PLANNING COMMITTEE – 7th November 2023

Reference Number: 23/00601/FL

Proposal Description: Reconfiguration and erection of new extensions to the Clay Cross Adult Community Education Centre and former DACES building including limited demolition within the Clay Cross Conservation Area. Erection of 16no new build commercial units. Extensive hard and soft landscape proposals around the buildings including enhancements and modifications to Market Street and Bridge Street (Major Development/Affecting Setting of a Listed Building/Conservation Area/Affecting Public Right of Way/NEDDC) (Amended Plans)

At: Masterplan Site Covering Land Roads and Buildings to the North and West of Broadleys, Clay Cross

Figure 8: Extract of plans for incubation units, open space, town square and access onto Broadleys

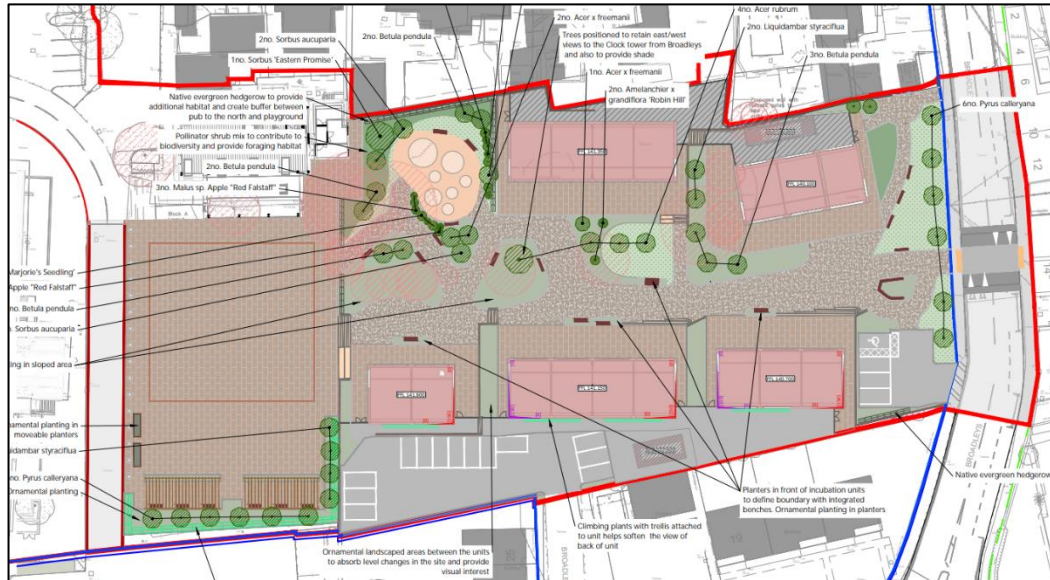
4.22 Broadleys Access – Drawing 06847-PL-D-0102 P0 has been submitted which demonstrates visibility splays of 2.4m x 18m to the south. It is noted that visibility is impeded by a fence to the south which was also picked up as an issue in the RSA. The HA would expect to see a 2.4m x 25m splay to the south and this can be controlled by way of condition.

4.40 In pure landscape design terms, it is unclear why the design has elected to use more organic, irregular shapes to the planting areas when the overall feel of the space is strongly rectangular in form and lends itself to perhaps a more formal arrangement of the landscaped areas with the use of some larger, long-lived trees that would make a more significant contribution to this space and wider townscape. Perhaps concepts such as hedging or avenues could be considered to help shape the space, define areas, and the way they might be used. Careful thought needs to be given to the proportion of soft and hard works so that there is a proper urban square that might be used for other events through the year such as farmer's markets, fetes, pop-up shops, etc. The easternmost end of the space against Broadleys could even be developed as a proper pocket park.

- 4.53 Works to Broadleys to create public realm does not seem to enhance the legibility of the scheme or provide a strong character that could help unify the proposed arrangements of the new buildings.

Figure 12: Proposed works to Bridge Street and bus stops

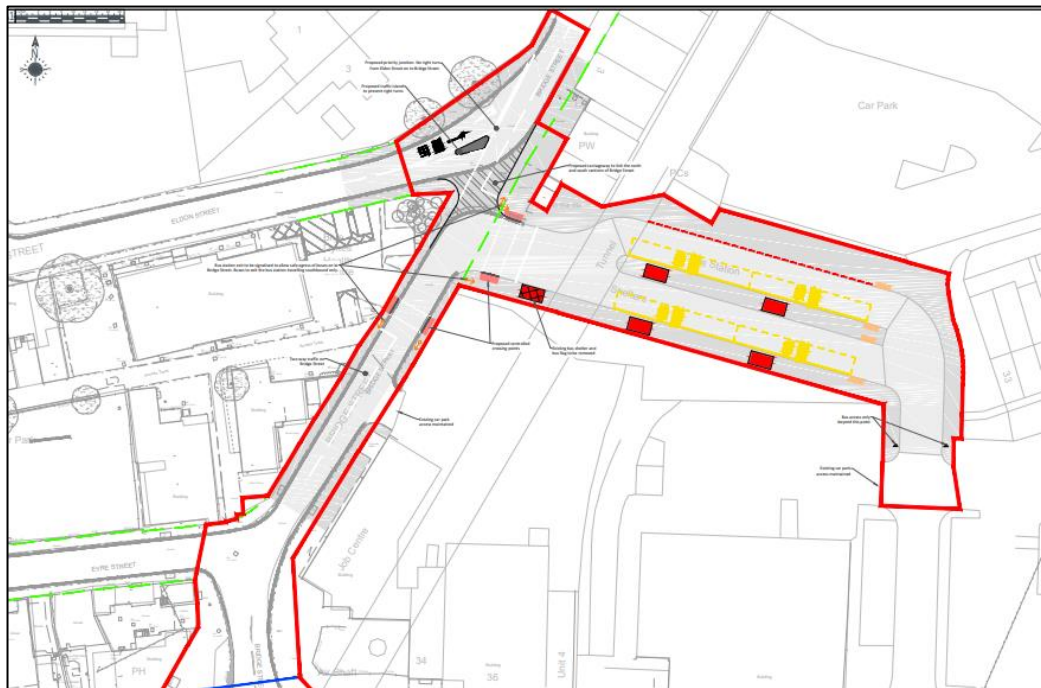
- c. The drawings show a (new) bus stop on the south side of Market Street which is required to accommodate services necessarily displaced from the Bus station as discussed in note 2. None of the drawings provide detail for this bus stop which must be constructed to accessibility standards and, if possible, be able to accommodate a shelter. The extent of the carriageway clearway marking may also need to be considered.

- d. As proposed, the Bus Station is reduced from five to four stands. This is, to some extent, mitigated by the requirement to provide a new bus stop on the south side of Market Street (note 3) which will accommodate services necessarily displaced because of the issues discussed above in a. and b.

Figure 20: Proposed pedestrianisation of Market Street and space leading to the town square

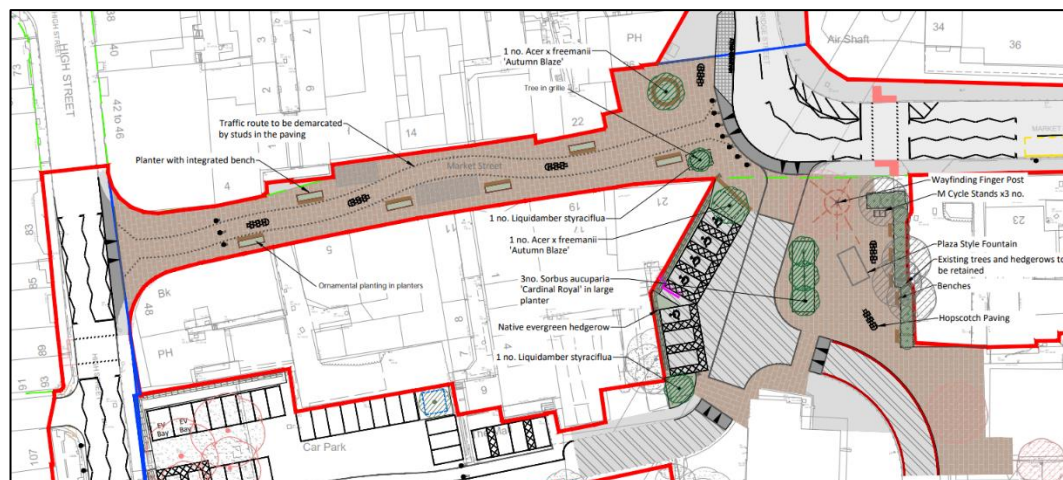
- 4.10 External Highway Works – Market Street – The HA note the pedestrianisation works to Market Street with access for cycles. New benches and planting will be provided. A ramp and bollards are provided to the east. Vehicles can access at certain times. The HA are satisfied with the proposals and advise the applicant Market Street will require a prohibition of driving order in order to pedestrianise the street. Thorough consultation should be undertaken beforehand to ensure there will be no objections by store owners fronting the highway.

- 4.58 The PPET would wish to see more compensation planting along Market Street, which is proposed to become pedestrianised, although there is insufficient space along Market Street to successfully establish trees of any meaningful stature within the narrow corridor between elevations. In addition, there appears to remain a need for a traffic route along Market Street, which includes clearance for authorised vehicle access and prevents the planting of any obstacle along this route. As such, compensation planting opportunities are limited to the east end of Market Street, which moves the beneficial attributes of air circulation and particulate interception away from the source of pollution along Main Street, or within the site to the further east alongside Broadleys.

Figure 21: Proposed works to Bridge Street

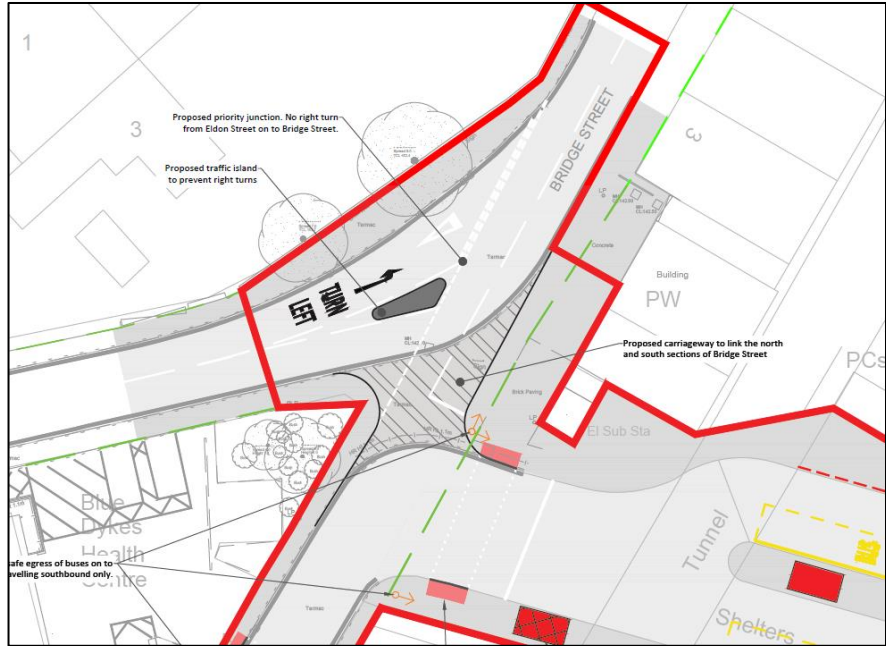
- 4.11 External Highway Works – Bridge Street – The HA note that this route will be re-opened to two-way traffic. To facilitate this, the bus station exit / Bridge Street junction will be signalised, with buses only permitted to turn left in this location (southbound). New controlled crossings will be provided on the bus station exit, as well as on the southern arm of Bridge Street. Vehicles exiting Eldon Street will only be permitted to turn left. The HA have reviewed drawing 06847-PL-A-0101 Rev P01 and are generally happy with the visibility splays and vehicle tracking. The HA advise that the issues raised by the Sustainable Travel team submitted as part of the DCC Policy comments dated 12/09/23 are addressed.

- 4.33 Issues arising for consideration:-
- a. New bus stops, each side of the road, be provided on the section of Bridge Street between Harris Way and Eldon Street. Some buses would lose access to existing stops on High Street which are close to Eldon Street / Aldi. These stops would help to maintain journey opportunities and provide passenger access to facilities in this part of the town centre. It is not considered that these would require shelter provision.
